Technical Note

Project No: ITL16195
Project Title: Broadwater Gardens
Title: HCC Highways Response
Ref: NM/MD/ITL16195-007
Date: 19 February 2021

Image 1.2: Light Panel Van Dimensions

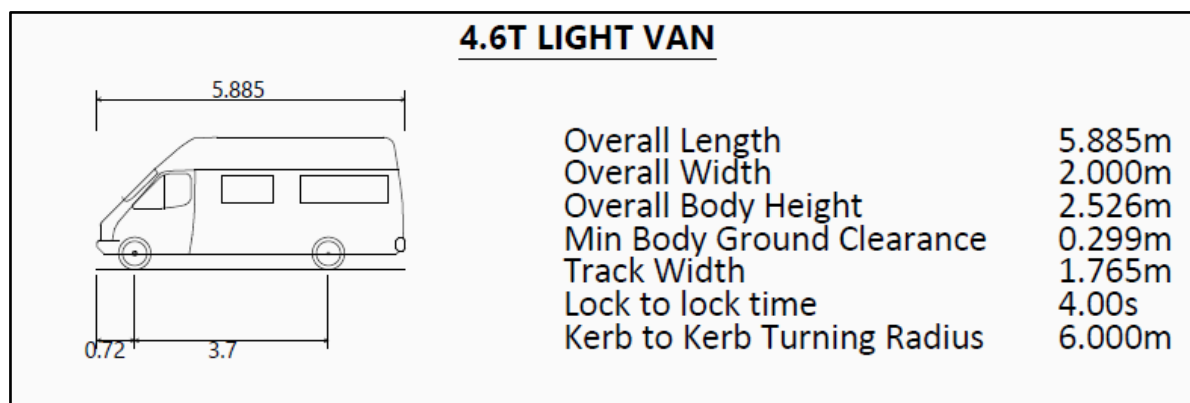
"It is requested that additional drawings are submitted that shows a box van (typical of online grocery deliveries and servicing vehicles) on a left-turn and also a right-turn into the site whilst a car is positioned at the give-way line."

- 1.7.1 A typical online grocery delivery is delivered in a vehicle similar to the 4.6t light van. The vehicle dimensions are provided In Image 1.2.

- 1.7.2 The swept path analysis of this vehicle at the site access, alongside a vehicle at the give way, is shown in Drawing No. ITL16195-GA-014A.
- 1.7.3 The drawing demonstrates sufficient width to allow for such vehicles to pass a car at the give way.

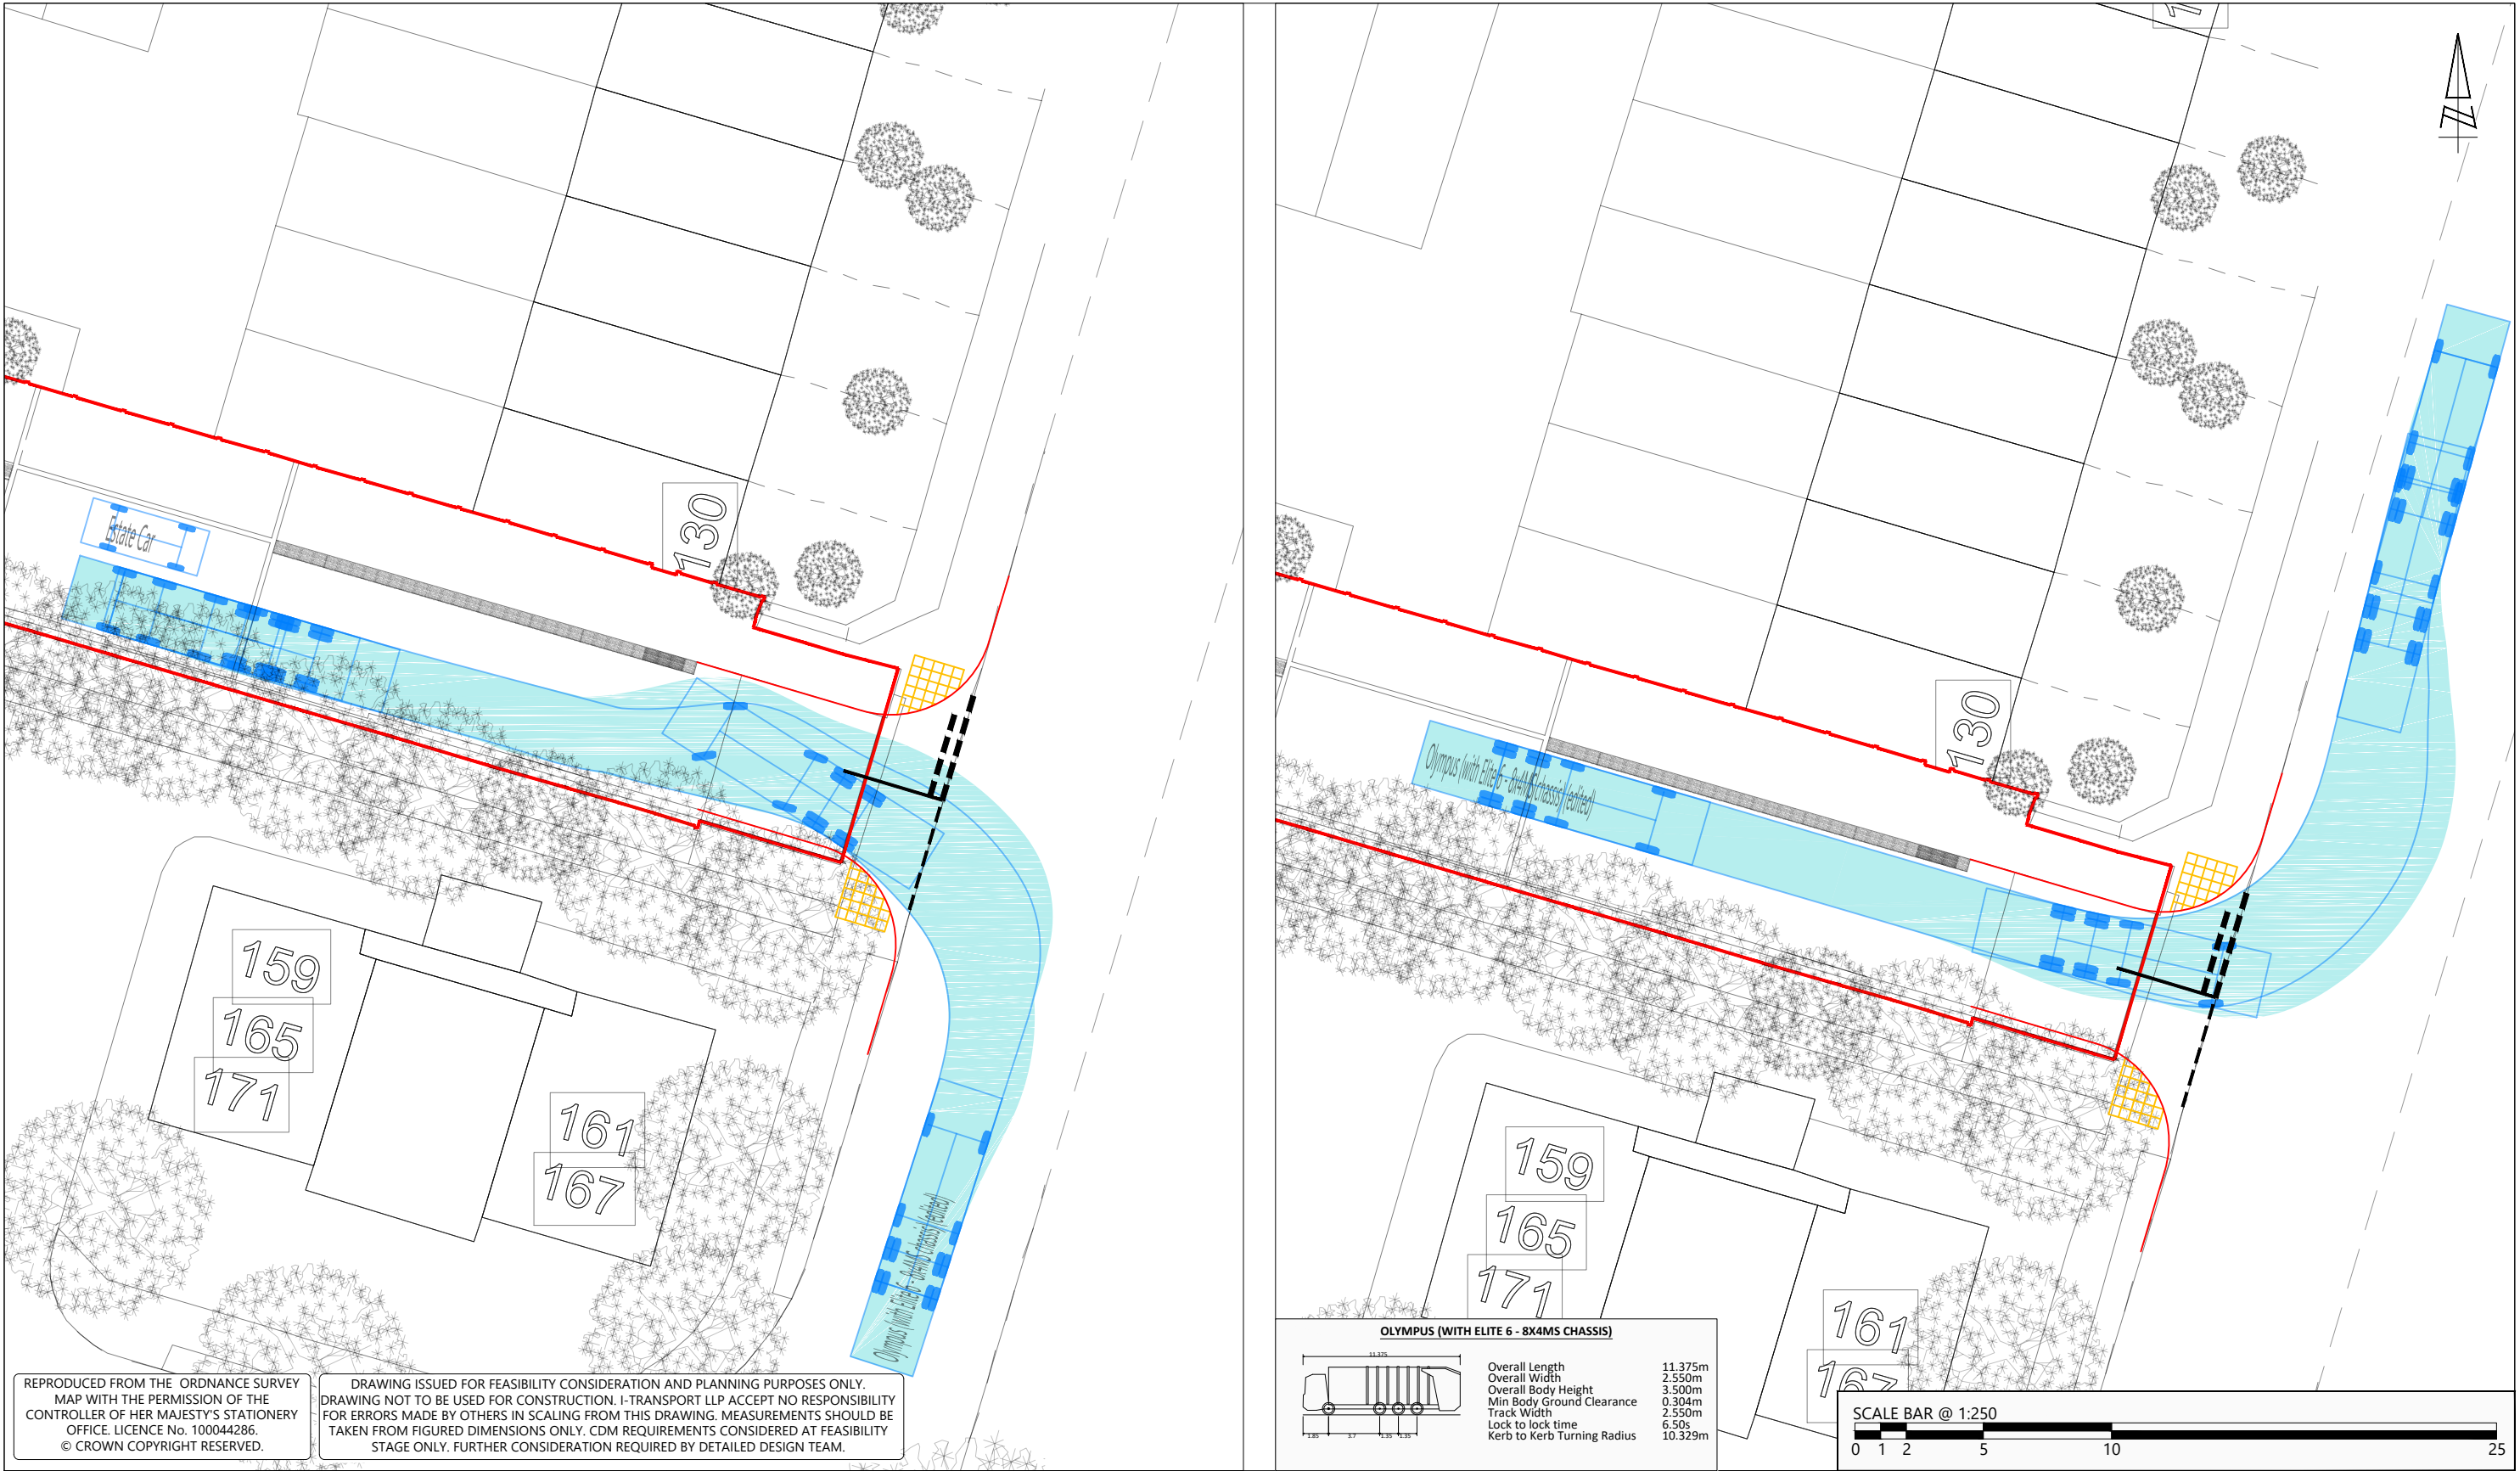
“It can be seen that upon entering the site, the body of the vehicle has the potential to overrun onto the shared footway / cycleway. No mitigation to reduce this risk to pedestrians or cyclists has been proposed”.

1.4.2 Notwithstanding the above points, the masterplan has been amended to provide a 5.5m width carriageway in this area. The updated site access junction arrangement is illustrated in drawing ITL16195-GA-005A.

1.4.3 As a result of the above, there is a minimum width of 1.75m of available footway. This is sufficient for a wheelchair and/or pushchair to pass and oncoming pedestrian in this area, as set out in Manual for Streets (MfS) (ref: see Figure 6.8 of MfS).

TITLE:		DRAWN:		CHECKED:		APPROVED:			
SITE ACCESS VEHICLE TRACK ANALYSIS - REFUSE VEHICLE		JMc		MD		NM			
		PROJECT No:		SCALE @ A3:		DATE:			
		ITL16195		1:250		26.01.21			
PROJECT:		CLIENT:		DRAWING No:				REV:	
BROADWATER GARDENS		WELWYN PARK HOMES LTD		ITL16195-GA-010				A

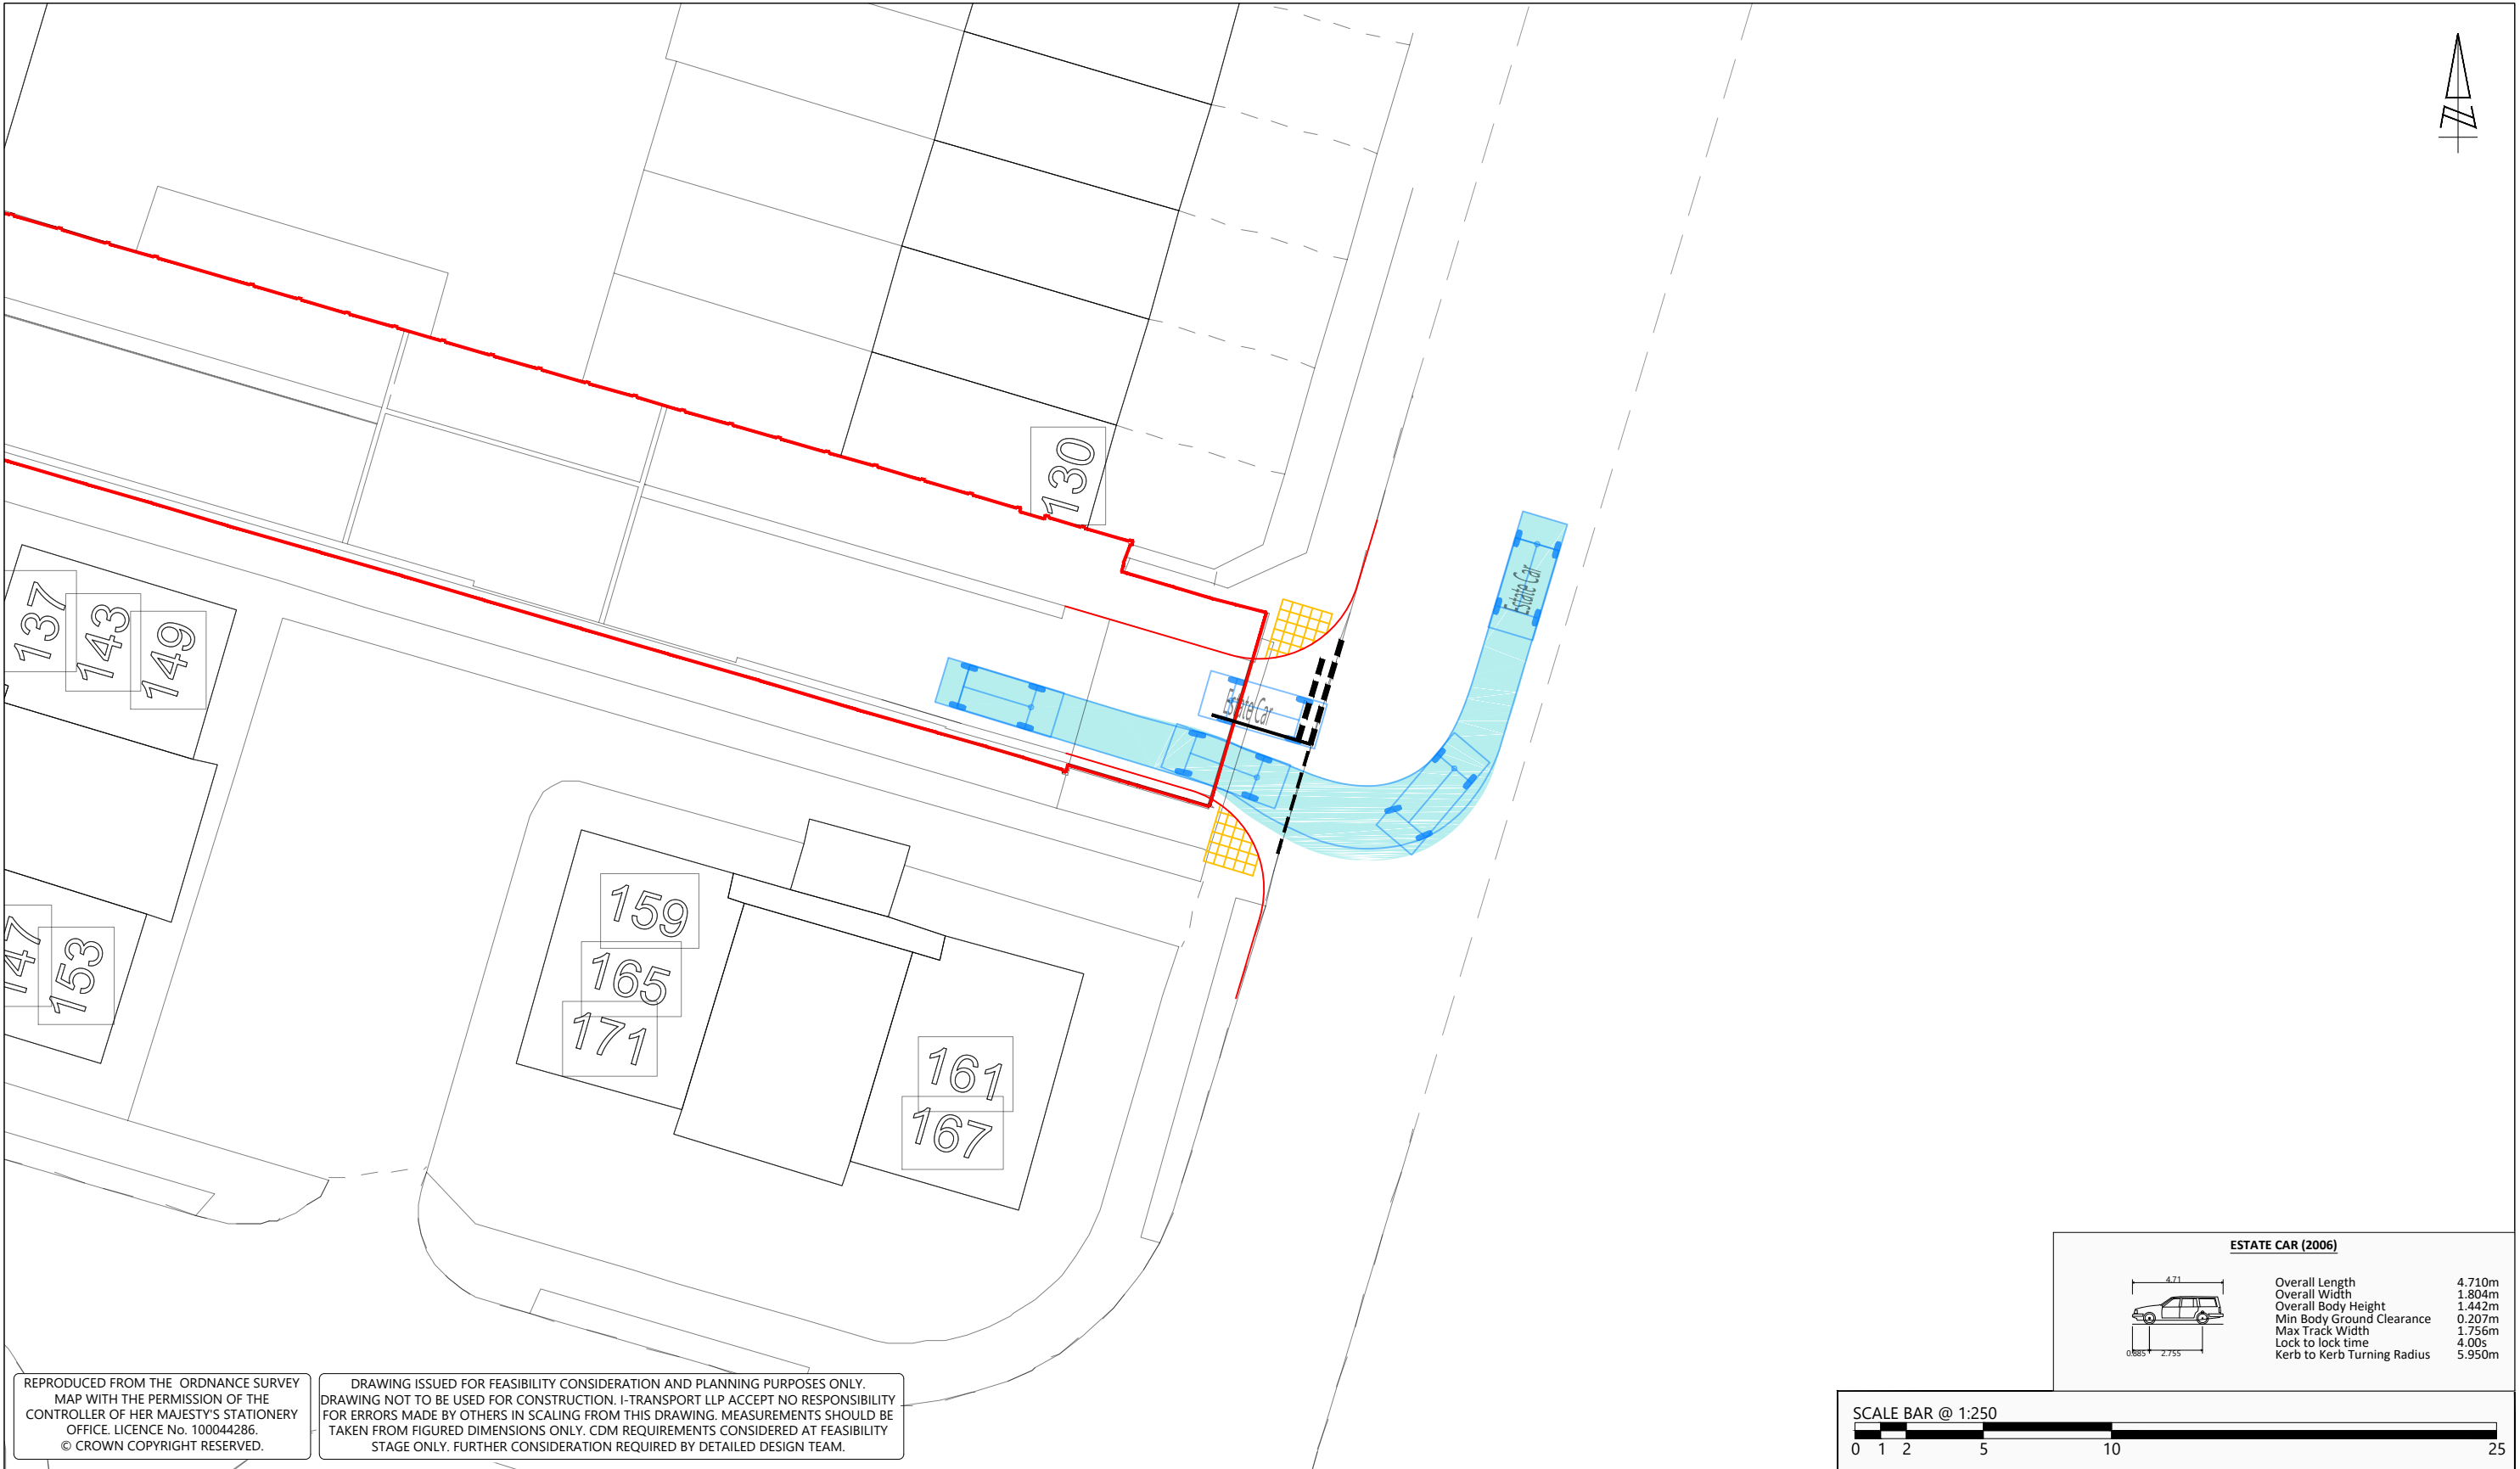
“refuse vehicle tracking shows incursion into the opposing carriageway when starting the left turn manoeuvre [from Broadwater Road] which could cause conflict with vehicles travelling in the opposing direction leading to possible head on collisions or side swipe collisions”

1.5.1 As set out in the Designer's Response (report ref: ITL16195-006) the easing of the radius at the site access junction to accommodate the infrequent movement of a large refuse vehicle is not required due to the following:

1.5.2 Notwithstanding these points, as set out above, the carriageway at the access has been widened and thus the updated swept path analysis of a refuse vehicle is provided in Drawing No. ITL16195-GA-010A. In addition, the swept path analysis if the most frequent vehicle movement likely to occur (a car passing another car) at the site access has also been updated and is illustrated in Drawing No. ITL16195-GA-011A.
